Project: [Project]
Regarding: **Site Progress/Quality Control – Security System Review**
Site Date: [Date]
Document Date: [Date]
Prepared by: **Jim Adams**

Site Progress/Quality Control SPQC Summary

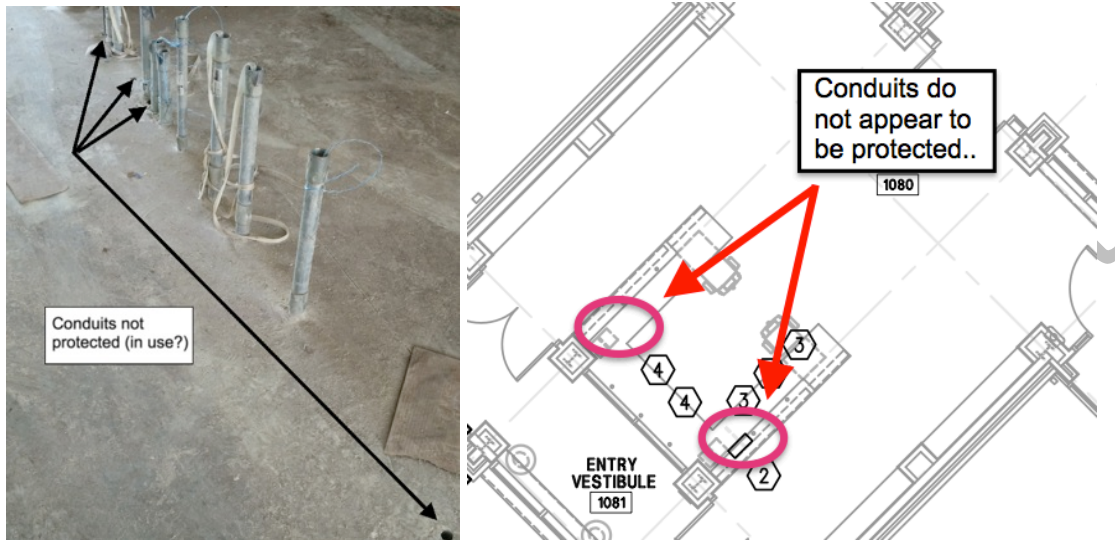
4. Exit sign above door 1400 entering Room 1401 Open Office is missing its directional chevron that would direct one to the right. As it is installed, the exit sign implies going through an access controlled door with the wrong swing (note door below exit sign)
